C AND C PLACE SUBDIVISION

APPLICATION NUMBER 15 DATE May 19, 2005

APPLICANT C And C Place Subdivision

REQUEST Subdivision

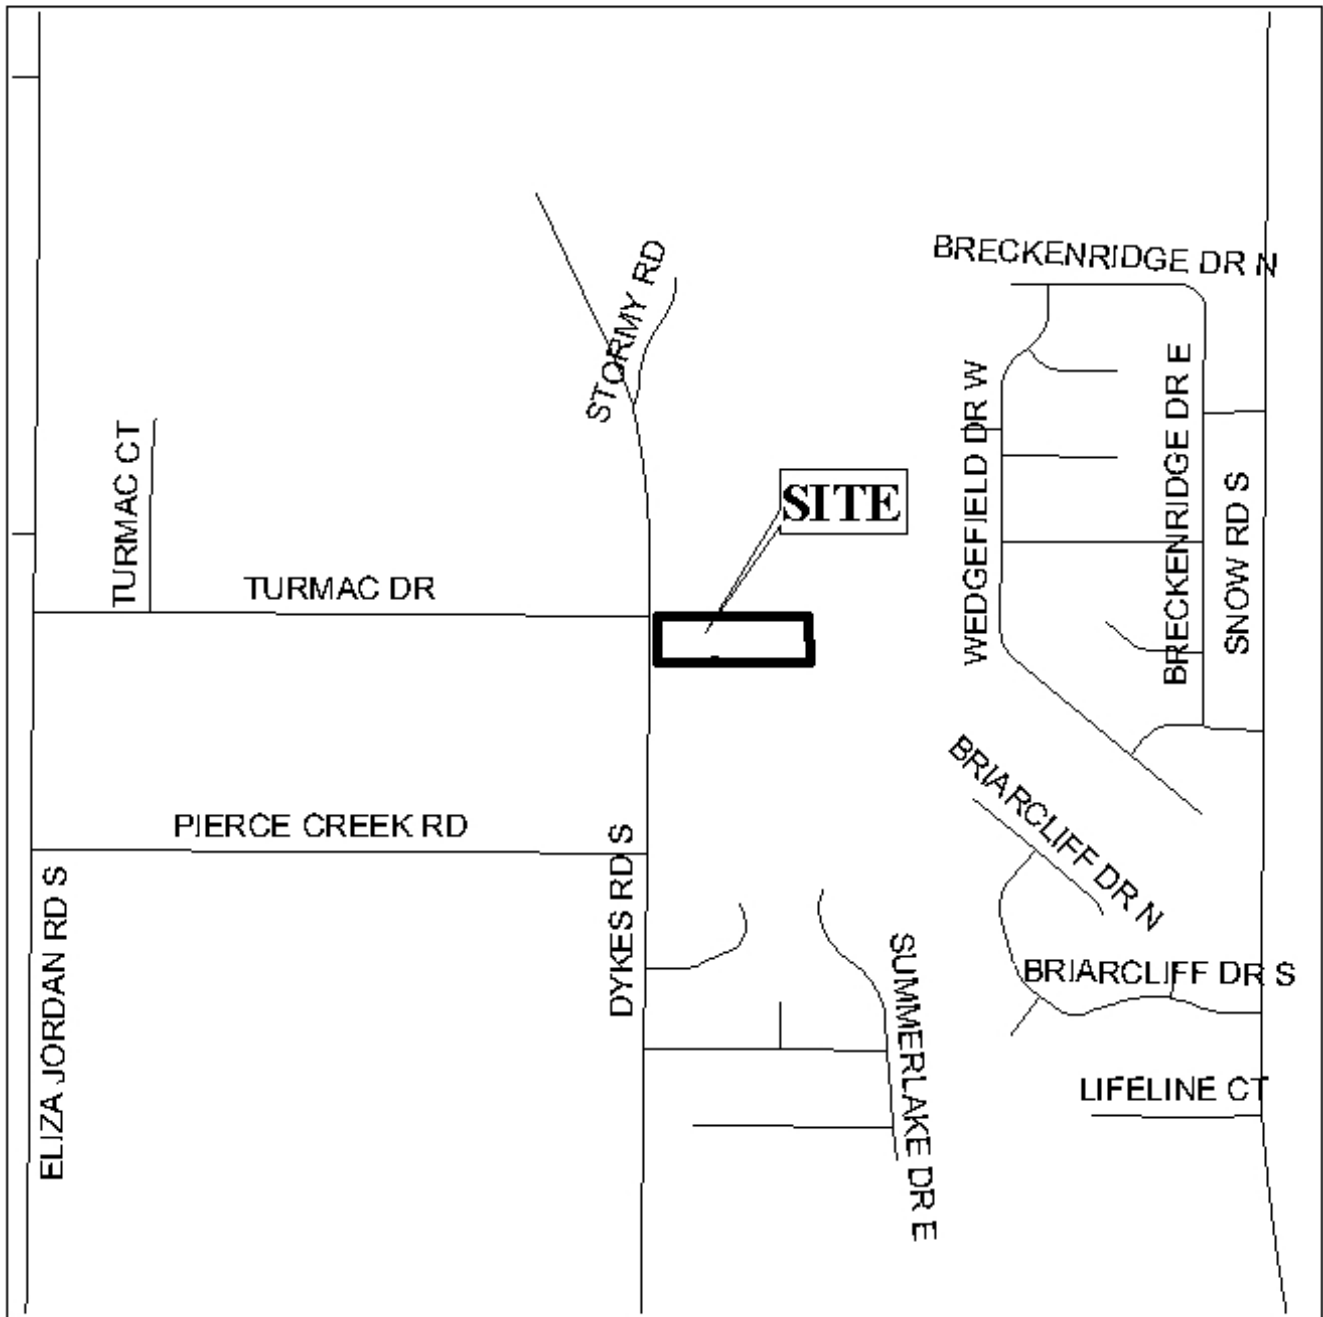
Engineering Comments: Must comply with the Mobile County Flood Damage Prevention Ordinance.

The site fronts Dykes Road South, which has a 60' right-of-way. While the proposed lots would meet the minimum lot dimension requirements, proposed Lot 2 would be flag-shaped. Section V.D.1. of the Subdivision Regulations states that "the size, width, depth, shape, and orientation of lots...shall be appropriate to the location of the subdivision." While not a desirable form of development, two other flag-shaped lots are in the vicinity of the site, so the shape may be considered appropriate to the location. However, a note should be required on the final plat stating that there will be no future subdivision of Lot 2, unless a dedicated and constructed County street is provided for access to Dykes Road.

As the site is situated on a lake and would be considered environmentally sensitive, approvals from federal, state, and local agencies will be required prior to the issuance of any permits.

The site is located in the County; thus any lots that are developed commercially and adjoin residentially developed property must provide a buffer, in compliance with Section V.A.7 of the Subdivision Regulations.

The plat meets the minimum requirements of the Subdivision Regulations and is recommended for Tentative Approval subject to the following conditions: 1) the placement of a note on the final plat stating that there will be no future subdivision of Lot 2, unless a dedicated and constructed County street is provided for access to Dykes Road; 2) approval by all applicable federal, state, and local agencies prior to the issuance of any permits; and 3) the placement of a note on the final plat stating that any lots that are developed commercially and adjoin residentially developed property must provide a buffer, in compliance with Section V.A.7 of the Subdivision Regulations.
